QUALITY ASSURANCE -- NON-CONFORMANCE REPORT

Location: Changxing Island, Shanghai, P.R. China **Report No:** NCR-000869
Prime Contractor: American Bridge/Fluor Enterprises, a JV **Date:** 19-Oct-2010
Submitting Contractor: Zhenhua Port Machinery Company, Ltd (ZPMC), Changxing Island **NCR #:** ZPMC-0831

Reference Description: QA found a missed UT indication after ZPMC had tested and accepted the weld in Segment 12AE Floorbeam Joint

NCR PROPOSED RESOLUTION

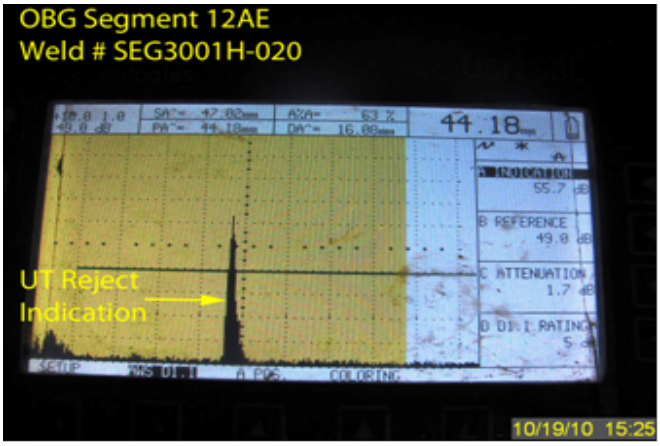
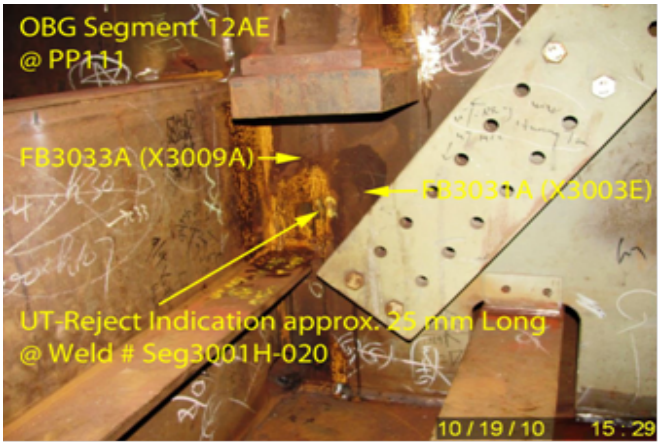
During the Quality Assurance (QA) Ultrasonic Testing (UT) verification of weld located on Segment 12AE, this QA Inspector discovered the following issue:

- One (1) Class “A” indication measuring approximately 25mm in length.
- The Indication rating is +5dB and length approximately 25mm.
- The thickness of the plate is 30mm and depth of the indication is approximately 15mm.

- The indication is located on the weld joint identified as SEG3001H-020.
- The “Y” location for this indication is approximately 500mm from Bottom plate.

- The weld is a Complete Joint Penetration (CJP) butt joint, joining Floor Beam FB3033A (X3009A) to Floor Beam FB03031A (X3003E).
- The indication is clearly marked by QA on/near the weld.

- This weld is identified as Seismic Performance Critical Member (SPCM).
- OBG Segment 12AE is located at the outside yard west side of Blast Shop 1.
-The Notice of Witness Inspection Number (NWIT) is 006956. The indication is located within the area that has been previously tested and accepted by ZPMC Quality Control (QC) personnel. As per the contract documents, ZPMC’s QC personnel are required to perform 100% UT inspection of this weld.

-AWS D1.5-2002, Section 6, Table 6.3; "Specifies a class A indication as having a dBs rating of +8 and lower for weld thicknesses 21mm through 38mm."

Contractor repaired and provided acceptable NDT records to close the issues. The proposed resolution is acceptable. This NCR is closed.

ZPMC acknowledged the indication was missed and has issued an internal NCR to address this problem. ZPMC has repaired the indication and is providing the NDT record to show the acceptance of this weld. Based on this, ZPMC is requesting closure of this NCR.

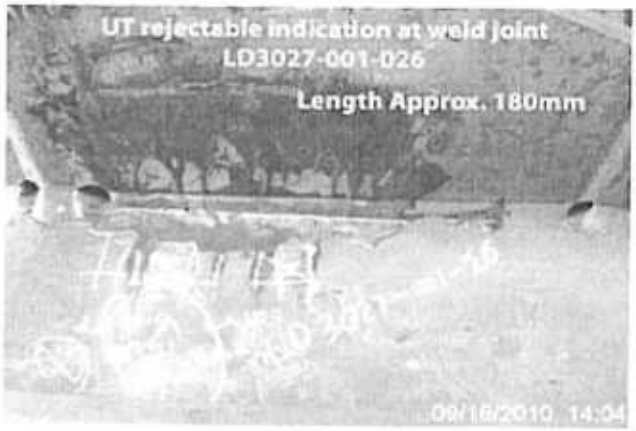
During the Quality Assurance (QA) Ultrasonic Testing (UT) review of welds located on Orthotropic Box Girder (OBG) segment13BE and 13CE, this QA Inspector discovered the following issues:

-Three (3) longitudinal linear class "A" rejectable indications measuring approximately 180mm~260mm in length.
-The welds are identified as LD3028-001-031, LD3027-001-026 and LD3030-001-053.
-Material thickness for all joints is 30mm.
-The indication db rating for joint LD3028-001-031 is a -6.
-The indication db rating for joint LD3027-001-026 is a -4.
-The indication db rating for joint LD3030-001-053 is a -5.
-The depth of the indications are from 20mm~23mm deep.
-The Weld LD3028-001-031 is joining longitudinal diaphragm (X3682A) to lifting Lug.
-The Weld LD3027-001-026 is joining longitudinal diaphragm (X3684B) to lifting Lug.
-The Weld LD3030-001-053 is joining longitudinal diaphragm (X3685A) to lifting Lug.
-All Welds are Complete Joint Penetration (CJP) "T" joint.
-All welds are Seismic Performance Critical Members (SPCM).
-The Y distance for joint LD3028-001-031 is 110mm from bottom cope hole.

-The Y distance for joint LD3027-001-026 is 40mm from bottom cope hole.
-The Y distance for joint LD3030-001-053 is 700mm from bottom cope hole.
-The indications are clearly marked on or near the weld.
-All components are located in fabrication Bay#3.

The Notice of Witness Inspection (NWIT) No. is 006680. The indications all joints are located within an area previously tested and accepted by ZPMC Quality Control (QC) personnel.

Applicable reference:
AWS D1.5-02 Section 6; Table 6.3 specifies a class "A" indication as having a rating of 8d and under for material thicknesses 21mm through 38mm.

These welds were designated to be PJP welds and no UT is required. The NWIT were submitted due to the internal fault between the floor QC & NDT operator of ZPMC. ZPMC is providing the MT records to show the acceptance of these welds and is requesting closure of this NCR.

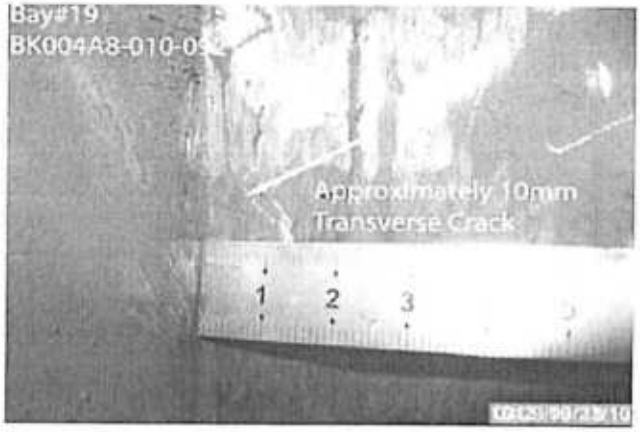
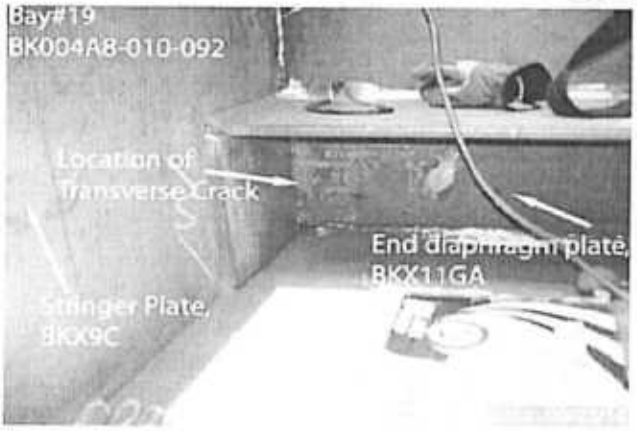
During the Quality Assurance (QA) Magnetic particle Testing (MT) review of welds located on OBG Bike path BK004A-010, this QA Inspector discovered the following issue:

-One transverse crack that measured approximately 10mm in length.

-The weld is identified as BK004A8-010-092.

-The weld is a Partial joint penetration (PJP) T joint, joining the Stringer plate (BKX9C) to the End diaphragm plate (BKX11GA).

-The Y Location is 100mm from the bearing plate.

-The crack is located within the area that has been re-tested and accepted by ZPMC Quality Control (QC) subsequent to the heat straightening procedure.

AWS D1.5 (02) Section 6.26.2 – "Welds that are subject to MT in addition to visual inspection shall have no cracks.

ZPMC acknowledged the indication was missed and has issued an internal NCR to address this problem. ZPMC has repaired the indication and is providing the NDT record to show the acceptance of this weld. Based on this, ZPMC is requesting closure of this NCR.

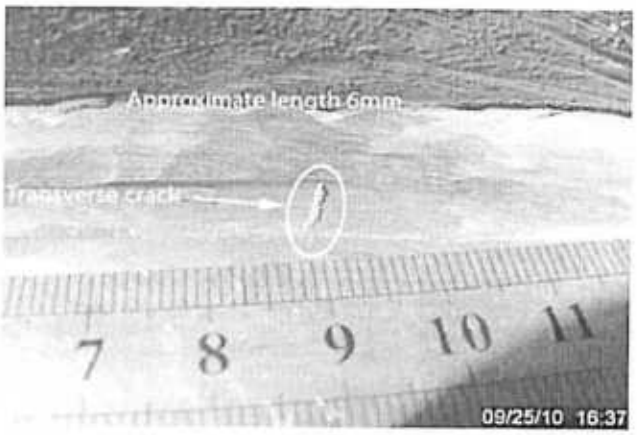
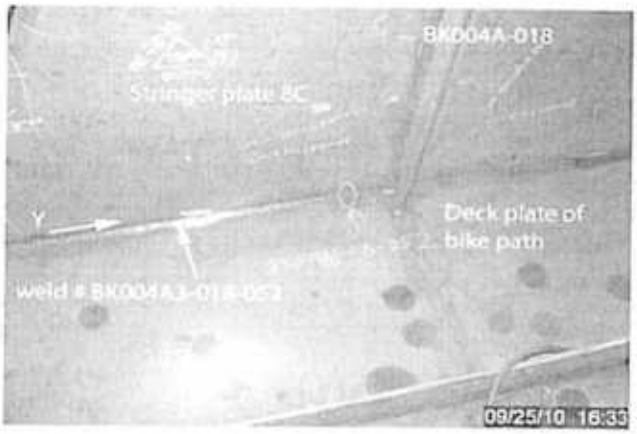
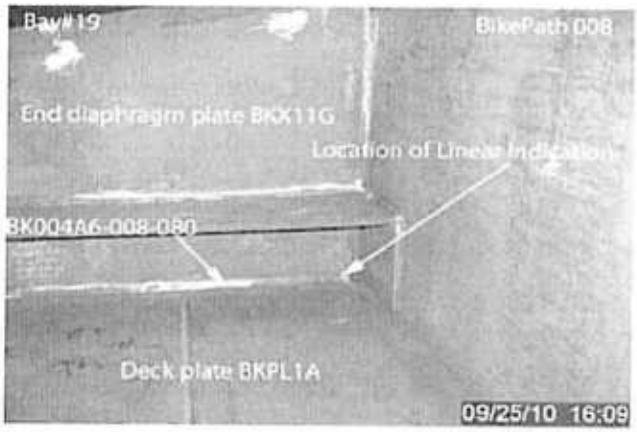
During the Quality Assurance (QA) Magnetic Particle Testing (MT) review of welds located on Bike Path 008, this QA Inspector discovered the following issues:

-One Longitudinal linear crack in the weld measuring approximately 15mm in length.
-The weld is identified as BK004A6-008-080.
-The weld is partial joint penetration (PJP), joining the End Diaphragm plate identified as BKX11G to the Deck Plate identified as BKPL1A.
-This weld joint is designated as Non-Seismic performance critical (Non-SPCM) weld member.
-The crack is clearly marked on the material near the weld.
-The OBG Bike Path 008 is located in Bay #19.

Quality Assurance (QA) Magnetic Particle Testing (MT) review of fillet welds located on OBG bike path BK004A-018, this QA Inspector discovered the following issues:

-One (1) transverse crack found on the weld measuring approximately 6mm in length.
-Y location of the indication is measured to be 2160mm.
-The crack is clearly marked on the weld joint.
-The weld is identified as: BK004A3-018-052.
-The Weld is a fillet weld joining the stringer plate (8C) to the deck plate of bike path.
-The member is located in bay 11.

AWS D1.5 (02) Section 6.26.2 – "Welds that are subject to MT in addition to visual inspection shall have no cracks.

ZPMC acknowledged the indications were missed and has issued an internal NCR to address this problem. ZPMC has repaired the indications and is providing the NDT records to show the acceptance of the welds. Based on this, ZPMC is requesting closure of this NCR.

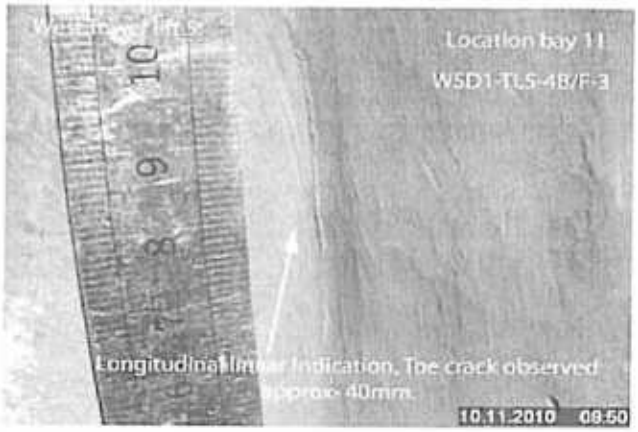
-One longitudinal toe crack measuring approximately 40mm in length.
-The weld is identified as: WSD1-TL5-4B/F-3.
-The Weld is a Complete Joint Penetration (CJP) weld, joining the grillage plate to skin plate.
-The material is Non Seismic Performance Critical Member (NON SPCM)
-The member is located in Bay 11.

-The Notice of Witness Inspection Number (NWIT) is 06917. The indication is located on CJP weld area that has been previously tested and accepted by ZPMC Quality Control (QC) personnel. As per the contract documents, ZPMC's QC personnel are required to perform 100% MT inspection of this weld. The attached photographs provide additional detail.

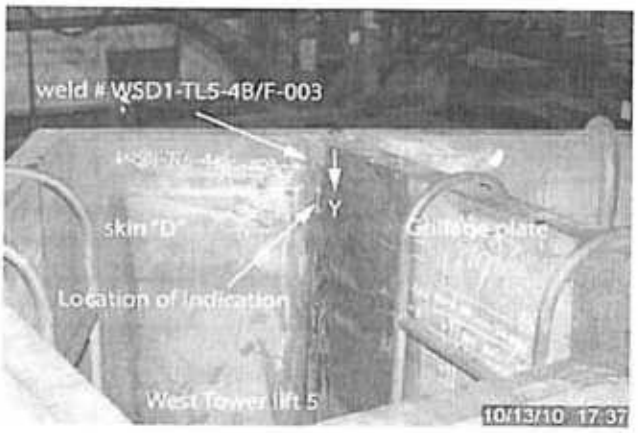
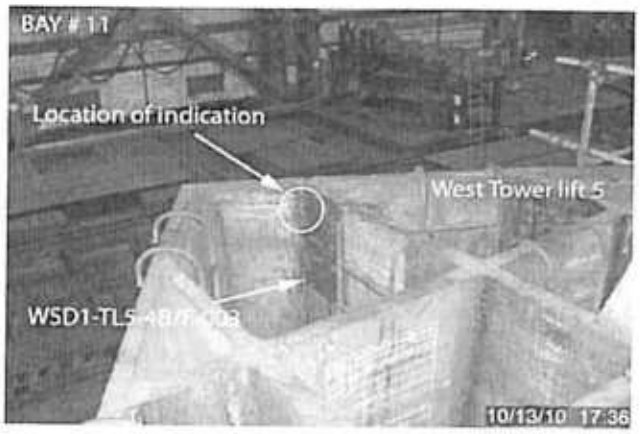
-Attached photographs provide additional location details.

AWS D1.5-02 Section 6.6.2 "The Contractor shall be responsible for visual inspection and NDT described in 6. 7 and necessary correction of all deficiencies in materials and workmanship in conformance with the requirements of Clause 3 and 6.26 and as specified elsewhere in the contract documents."

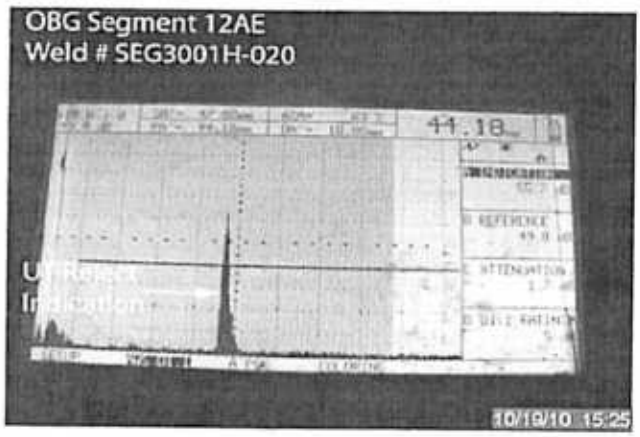
-AWS D1.5-2002, Section 6, Table 6.3; "Specifies a class A indication as having a dBs rating of +8 and lower for weld thicknesses 21mm through 38mm."

Contractor proposes to repair the weld indication, and provide NDT report to prove the weld is acceptable. Contractor will monitor the inspector who missed the indication, and take disciplinary action should be continuously making similar mistakes.
